PLANNING UNIT REPORT
DEPARTMENT OF PLANNING AND DEVELOPMENT
October 24, 2005

RE: I.D. # 02046: Zoning Map Amendment I.D. 3136 To Rezone 425 W. Washington Avenue from R6 (General Residence District) to PUD-GDP-SIP

DATE: October 12, 2005
TO: Plan Commission
FROM: Larry D. Nelson, P.E., City Engineer *[Signature]*
SUBJECT: 425 West Washington Avenue Planned Unit Development (GDP/SIP) & Demolition

1 FIFTH FLOOR PLAN
 AT SCALE 1/8" = 1'-0"

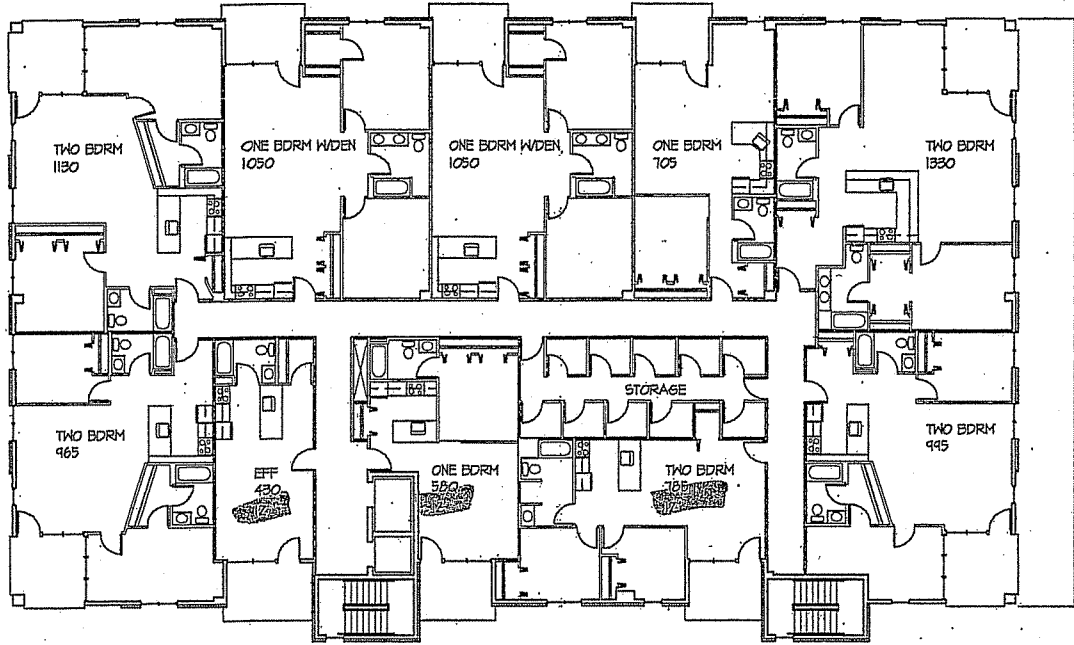
The applicant has submitted an Inclusionary Dwelling Unit Plan (IDUP) indicating intent to meet the inclusionary zoning provisions of the Zoning Ordinance, with six of the 40 rental apartment units proposed to be affordable under the terms of the ordinance. All six units will be available to families earning 60% of the area median income (AMI) as allowed for a project containing four or more stories and providing 75% of its parking underground. The six units equal the minimum number of units required by ordinance for this project. A representative number of affordable units are provided, with one studio, two one-bedroom units, and three two-bedroom units, though half of the units are located on the first residential floor (Fifth) and no units are proposed on the Eighth Floor.
